CORONADO RADIO MODEL 05RA4-43-9876A

Bottom Chassis View.

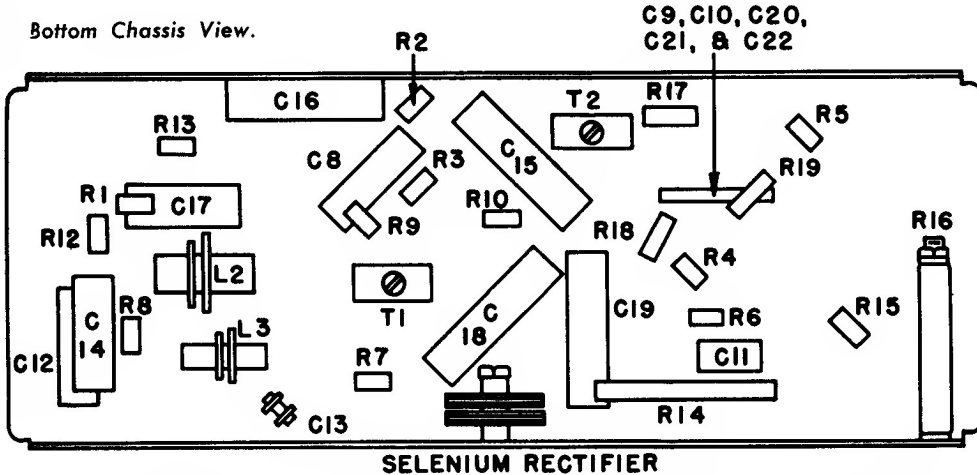
Sets with the
suffix "B" in-
stead of "A",
use 1L4 tubes
instead of 1U4,
and a switch
operated by
power plug and
chassis socket.
